NPIC/TSSG/ESD/TEB-34-68 24 December 1968

MEMORANDUM FOR:	Chief, Development & Engineering Division, TSSG		
	ATTENTION:			
•	THROUGH:	Chief, TEB/ESD/TSSG/NPIC Chief, ESD/TSSG/NPIC — / Chief, ESD/TSSG/NPIC		
	SUBJECT:	Interim Test Report on the MonoRad, R&D Poject No. 02308		
•	REFERENCES:	Test Plan - dated 22 October 1968

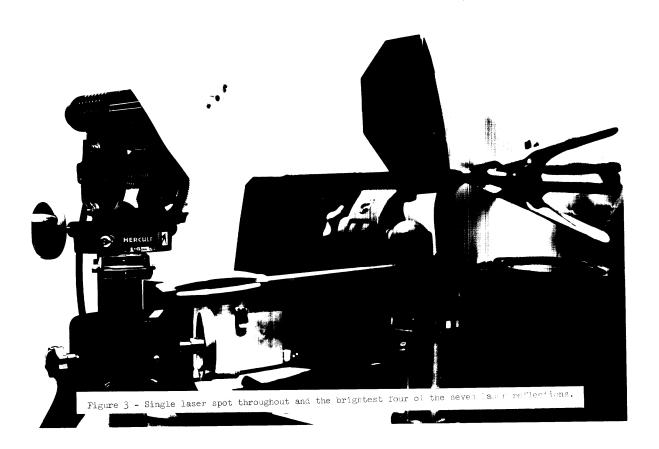
- 3.6. The light loss through the MonoRad is very large. This will, of course, hurt its application to low contrast imagery. Figures 2 and 3 show the laser setup and the multiple laser reflections that were observed. This indicates that some of the light loss could be eliminated in production versions of the MonoRad. It would be best to test the operational suitability of the concept rather than the prototype by using high contrast imagery for the operational suitability test.
